ST. LUCIE PLANT UNIT NO. 1

AMENDMENT TO FACILITY OPERATING LICENSE

Amendment No. 70  
License No. DPR-67

SAFETY EVALUATION BY THE OFFICE OF NUCLEAR REACTOR REGULATION

FIGURE 3.2-1 ALLOWABLE PEAK LINEAR HEAT RATE VERSUS FRACTION OF CORE HEIGHT

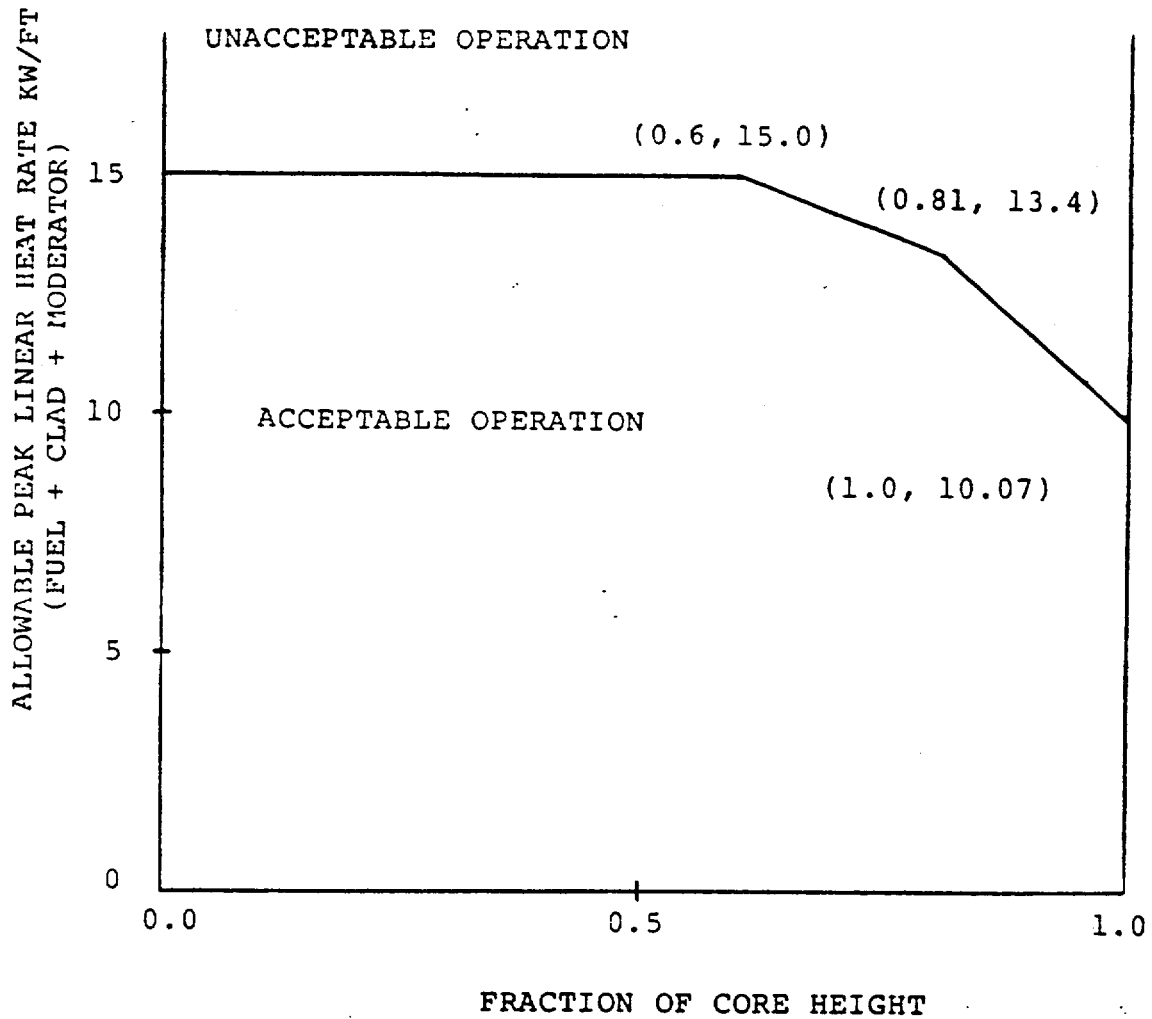
This amendment revises the Technical Specifications to change the Linear Heat Generation Rate (LHGR) Limiting Condition for Operation (LCO) from a constant value of 15.0 Kw/ft to an axially dependent limit. In addition, the Local Power Density LCO curve and the associated Bases are changed. The fuel densification and thermal expansion uncertainty factor of 1.01 is deleted. Added is a license condition requiring the submittal of a supplement to EXXON Report XN-NF-85-117 for the Commission staff's review and approval. This supplement is to cover the complete large break LOCA spectrum results to demonstrate full compliance with the criteria of 10 CFR 50.46 and Appendix K to 10 CFR Part 50 with 15% tube plugging which will be considered following receipt of the supplement. Action on your request to allow you to exceed the limits of Figure 3.2-1 during the performance of Specification 4.1.1.4.2 is deferred until further justification is provided that shows that you can verify that the limit of 10 CFR 50.46 is not exceeded.

The proposed changes will change the LHGR LCO from the constant value of 15 Kw/ft to an axially dependent LHGR limit. The allowable local power density limits for operation when incore detectors are out of service will also be lowered. The third change will be removal of the LHGR uncertainty factor for axial fuel densification and thermal expansion. The final change requested will not require the LCO on LHGR to be met during Moderator Temperature Coefficient testing.

The bounding power distribution was determined from the 0.8 DECLG break system bounding conditions. Two points were determined. At 0.6 of the active core length (0.6x/1) the peak LHGR was found to be 15 Kw/ft. A peak LHGR of 13.4 Kw/ft was found at the 0.81x/1 elevation. These power distributions meet the criteria of 10 CFR 50.46 and are the basis for the proposed license amendment, Item 1 of Reference 3.

The change to the LHGR LCO, Technical Specification 3.2.1, results in a more restrictive limit for the allowable peak linear heat generation rate. The limitation on LHGR ensures that in the event of a Loss of Coolant Accident (LOCA), the peak temperature of the fuel cladding will not exceed 2200°F. A review of the results as presented in XN-NF-85-117 (St. Lucie 1 Revised LOCA-ECCS analysis with 15% Steam Generator Tube Plugging) indicates the following.

3.2.1 The linear heat rate shall not exceed the limits shown on Figure 3.2-1.

FIGURE 3.2-2

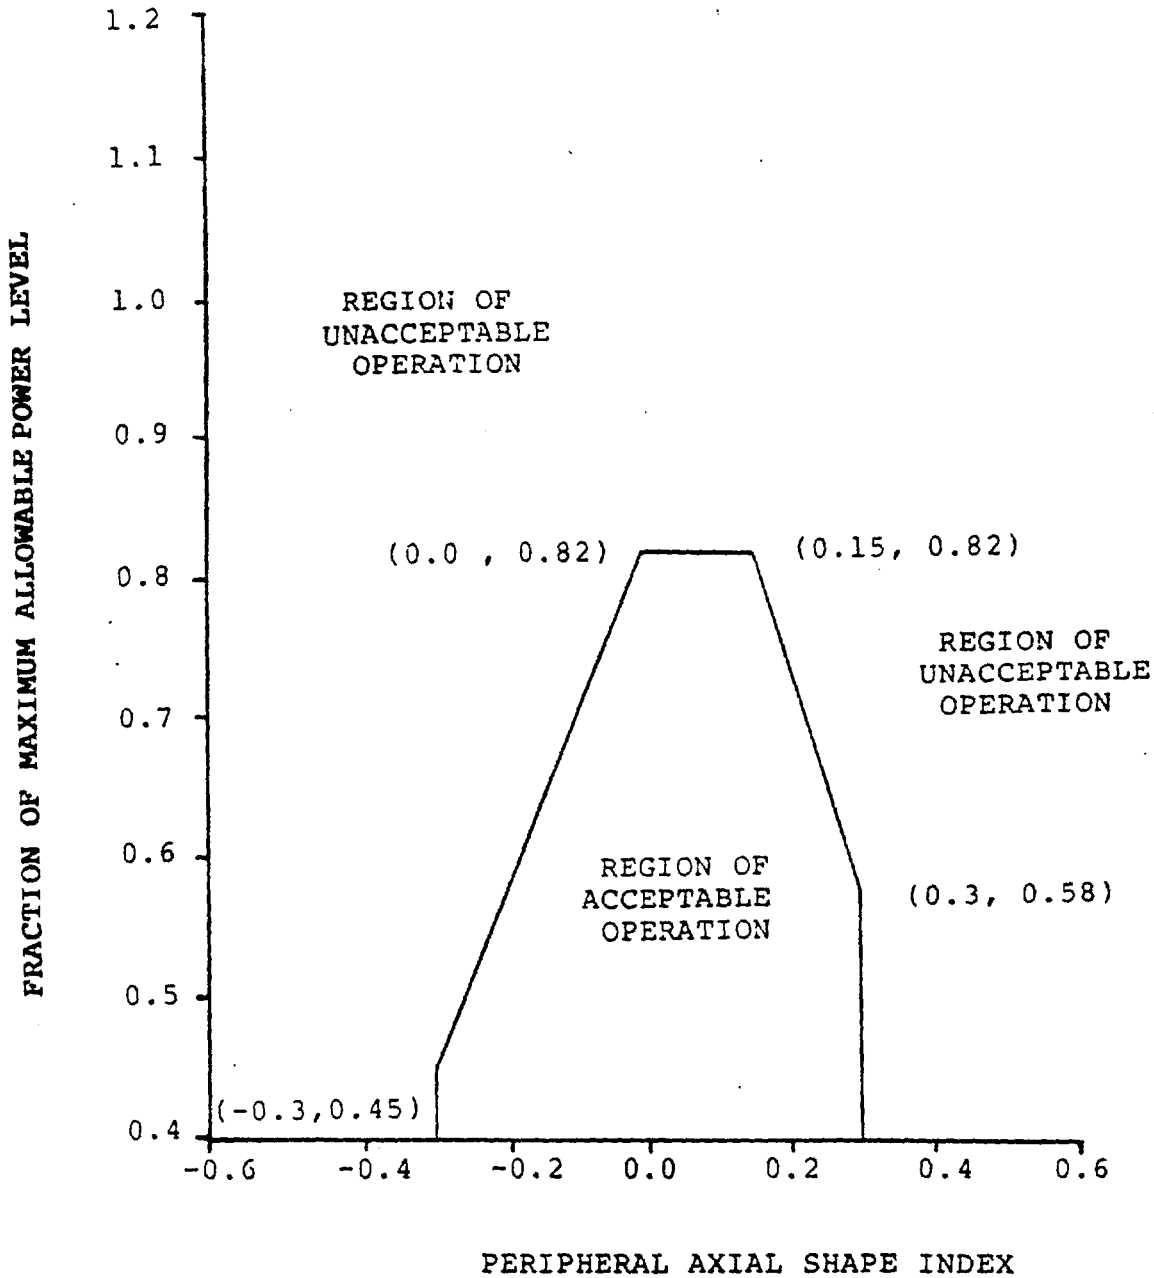
The allowable local power density limits for operation when in-core detectors are out of service (Technical Specification 4.2.1.3, Figure 3.2-2) has been narrowed to reflect the changes to the linear heat generation rate limit. ENC statistical methodology was used to determine the allowed power versus Axial Shape Index incorporating appropriate uncertainties.

- a. Verifying at least once per 12 hours that the full length CEAs are withdrawn to and maintained at or beyond the Long Term Steady State Insertion Limit of Specification 3.1.3.6.
- b. Verifying at least once per 31 days that the AXIAL SHAPE INDEX alarm setpoints are adjusted to within the limits shown on Figure 3.2-2.
